D5.6 Xerox® AltaLink® Product Enhancement Document for Version 114.xxx.022.12100

Description of new features and enhancements to the products specified below.

Release Date: May 9,2022

1. ID Card Copy App enabled at default

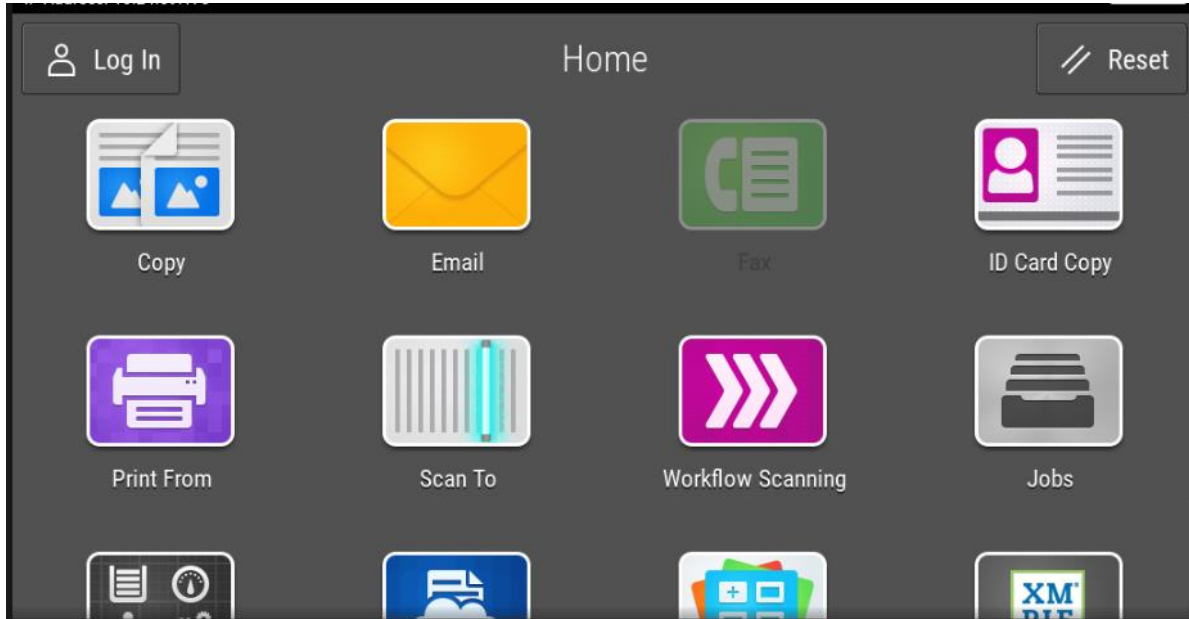
The ID Card Copy App will now be displayed by default to users on the LUI. The user will no longer need to customize their LUI display to use this app. This allows accounts that do not permit users to customize their display to have access to this feature.

The EWS Properties-> Apps -> Enablement screen has been updated so that the admin can enable/disable applications "Availability" and set the "Visibility" of the application on the LUI screen.

3. Addition of DHCP IPv6 Unique Identifier (DUID) to Configuration Sheet

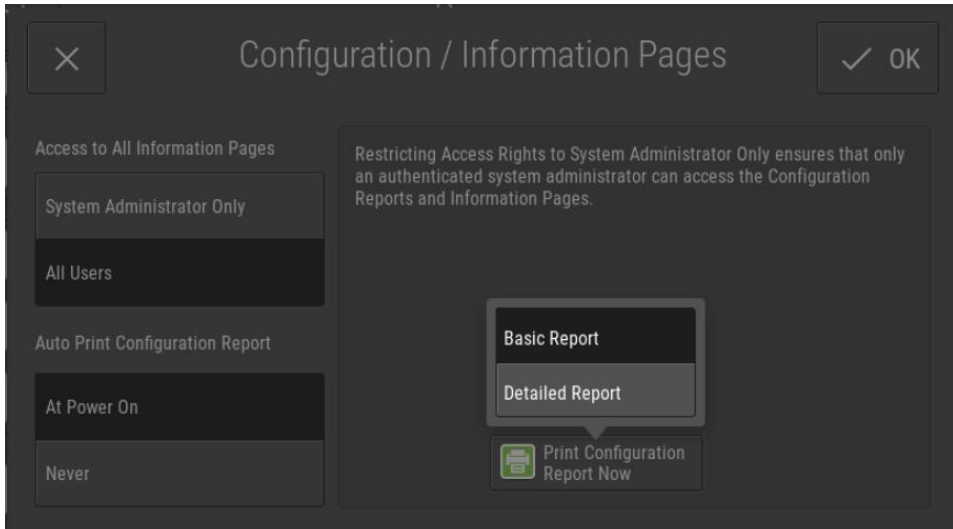
The DHCP IPv6 Unique Identifier (DUID) in Link Layer format will be displayed on the printed configuration sheet

when IPv6 is enabled. The DUID information is labeled “DUID (DHCP Unique Identifier)” under the Protocols heading. Additionally, the DUID identifier can be obtained from the EWS Configuration Report when IPv6 is enabled.

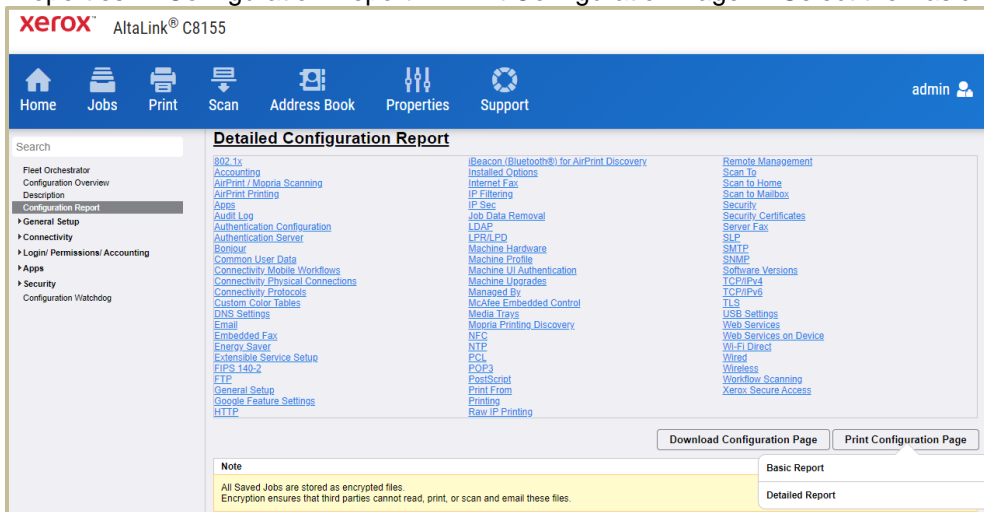
From the LUI, the Admin can configure the device to control access to the Basic and Detailed configuration reports. (Device App -> Tools -> Configuration / Information Pages). Printing of the reports is also available by selecting “Print Configuration Report Now” & selecting the Basic or Detailed Report.

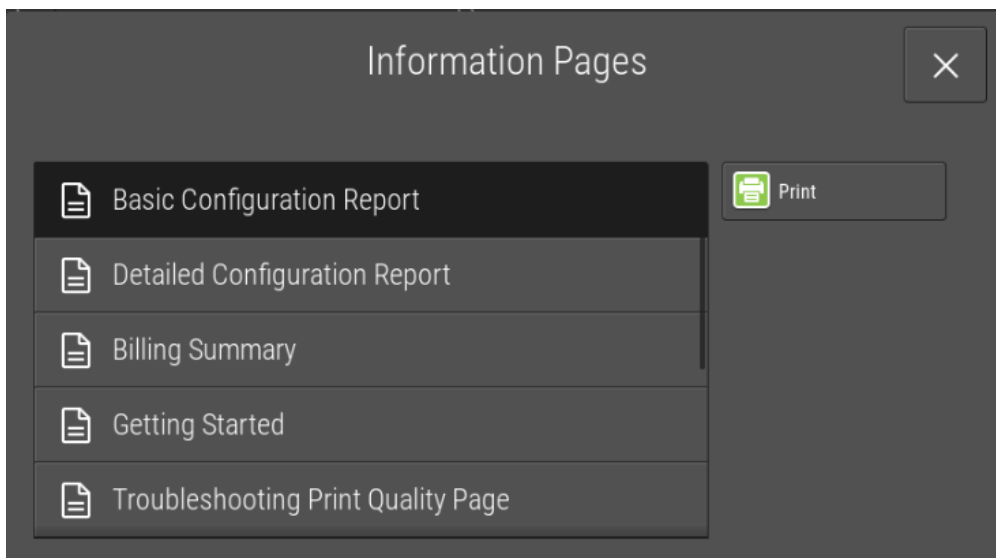
Printing of the configuration reports from EWS:
Properties -> Configuration Report -> Print Configuration Page -> Select the Basic or Detailed Report

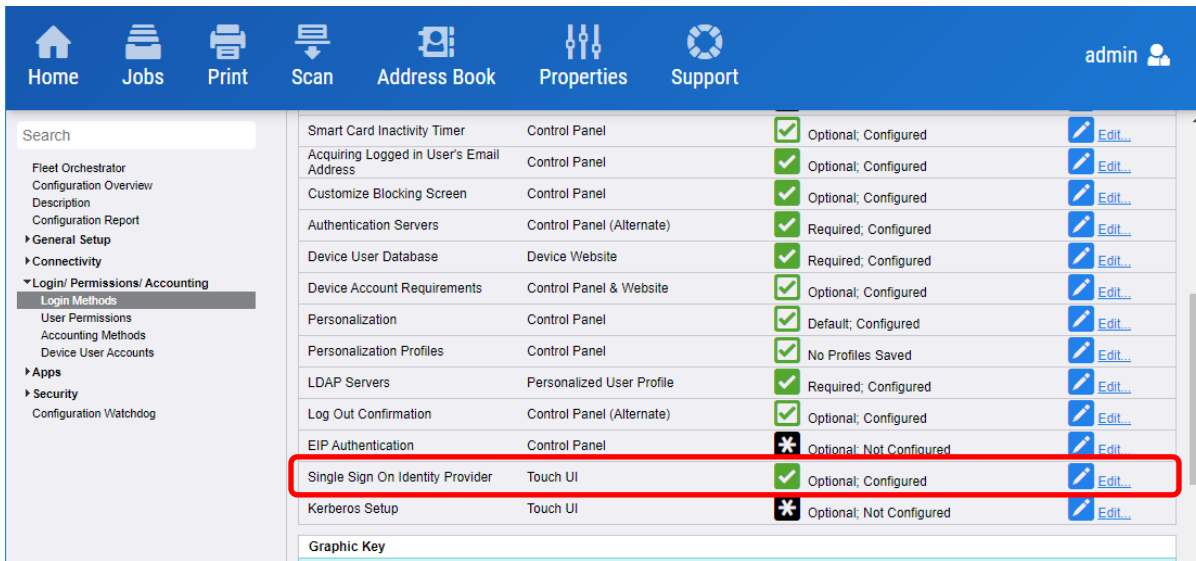
- Under the settings for Smartcard or Network Authentication select Edit for Single Sign-On Identity Provider (see pictures below).
- Check the Enable Box
- Enter of the url for the ADFS server windowstransport endpoint
- Enter the SAML Token Access Code. The SAML Access Token Code can be any string, 14 – 64 characters that the admin wants to use. Note that SAML Token Access Code entry must match the entry made at App Gallery when configuring and downloading the App Gallery SSO apps.
- Select Save. Note that if you go back into the setup and change any setting you will need to re-enter the SAML Access Token Code
